KINGSTON TOWNSHIP PLANNING COMMISSION
May 26, 2020
MINUTES

**Mt. Olivet Cemetery Minor Subdivision of 612 Mt. Olivet Road, Wyoming, PA
PIN No. D9-A-13, OFD – April 7, 2020**

RE: Mt. Olivet Cemetery Minor Subdivision Final Plan – 1st Revision Submission

**RE: Mt. Olivet Cemetery
Final Plan - Minor Subdivision
Kingston Township, Luzerne County, PA
Application No. 5537**

LUZERNE COUNTY RECORDER
 BURKE LAND SURVEYING
 FINAL PLAN - HUNGR SUBDIVISION
 812 Mt. Olivet Road
 Scale: 1" = 150'
 DATE: 06/16/2010
 SHEET: 1 OF 1

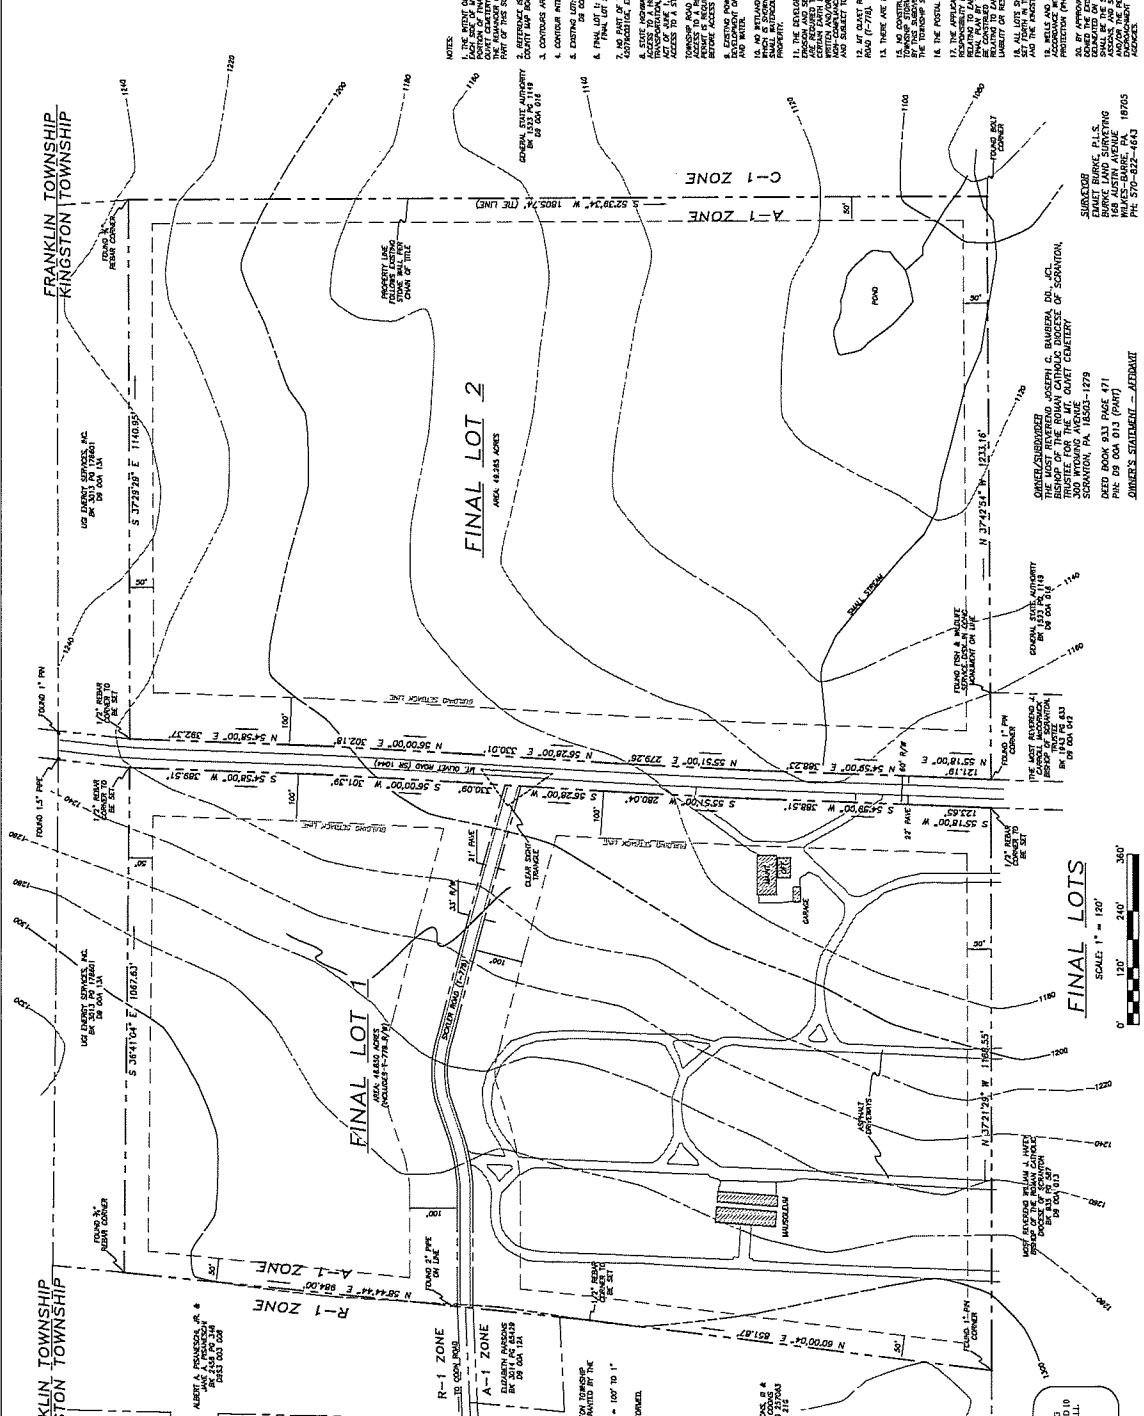
1. *§801.A. Plan scale not in accordance with the requirements of this section. A modification/waiver may be appropriate. This should be noted on the plan. A waiver for plan scale is being requested, and is noted on the plan. **We acknowledge requested waiver. P.C. action required.***

2. *§801.C.5(a) We cannot confirm if all watercourses and lakes have been shown. The watercourses and the pond have been shown. **We do not see any watercourses indicated on the plan. Clarification suggested.***

3. *§801.C.5(b) We cannot confirm if all wetlands have been shown. Planning Commission shall determine if Notes 10 and 17 are adequate to meet the requirements of this section or if they wish to consider a modification/waiver. A waiver is being requested, and is noted on the plan, to relieve the applicant from the requirement to provide a wetland delineation. No construction is proposed. **We acknowledge requested waiver. P.C. action required. Please be advised that our interpretation is that the purpose of showing wetlands is not so much based upon whether or not construction or earth disturbance is being proposed as part of the subject subdivision, but as a matter of record should the lot be sold or***

future building permits be applied for. The providing of wetlands now may prevent related issues in the future.

4. §801.C.5(d) *We cannot confirm if all buildings or other significant features have been shown. At a minimum, we would think that the mausoleum structure and the office and maintenance building should have been shown. Buildings and significant features have been shown, specifically, the maintenance building, garage, office, and mausoleum. No further comment.*

5. §801.C.5(e) *We cannot confirm if all historic sites or structures have been shown. No historic sites or structures are known to exist at the site. No further comment.*

6. §801.C.6. *Please clarify if Sickler Road is a dead end as shown or does it continue through to the adjoining property. Sickler Road continues to Coon Road, and the plan has been revised. Satisfied.*

7. §801.C.9(m) *Statement relative to the type water supply not provided. Water supply is on-site for Final Lot 1 (see Note 9). If served by a well (or wells), it/they should be shown. P.C. response may be required.*

8. §801.C.9(n) *Statement relative to the type of sewage disposal not provided. Sewage disposal is on-site for Final Lot 1 (see Note 9). Where is the on-lot system located? It should be shown on the plan. P.C. response may be required.*

9. §801.C.9(r) *Any Zoning District boundary that falls within the plan coverage area should be shown along with any Municipal Boundary division lines, which would be common with Zoning District boundary delineations. The municipal boundary with Franklin Township is now shown. Zoning Boundaries with R-1 and C-1 districts are now shown. Satisfied unless P.C. or Zoning Officer has further comment.*

10. §801.D.1. *Surveyor's Statement does not certify the error of closure accuracy. Error of closure has been added to the Surveyor's Certification. Satisfied.*

11. §801.D.5. *A copy of a receipt from the Luzerne County Planning Commission for the delivery and acceptance of the application submission package should have been provided. Any comments received from the LCPC should be addressed accordingly unless directed otherwise by the Kingston Township Planning Commission. Luzerne County review letters have been received and are being addressed below. We are satisfied with the responses to the Luzerne County comments.*

12. §801.E.1(b) *The plan does not indicate any drainage easements. No recorded drainage easements were found. No further comment.*
13. §801.E.1(c) *Clear sight line triangles should be shown for Sickler Road. Satisfied. No response was provided in the response letter. However, we see that the clear sight triangle has been added to the plan on Sickler Road at its intersection with Mt. Olivet Road.*

14. §801.E.2. *This note should be added to the plan. Note 18 has been added to the plan. Satisfied.*

15. §801.E.3. *This note should be added to the plan. Note 19 has been added to the plan. Satisfied.*
16. §801.F. *Although some of the notes provided are similar to the notes required of this Section (3, 4 and 5), we recommend that the applicable notes on the plan be revised to read exactly the way the language appears in this Section of the Ordinance. Note 20 has been added to the plan. Also, note 8 has been revised. No further comment.*
17. *All certification and signature blocks shall be fully executed at the time in which the plan is presented for final approval signatures. Acknowledged. No further comment.*
18. *Zoning Officer shall confirm all Zoning Data provided on the plan. Zoning Officer's review is pending. No further comment.*
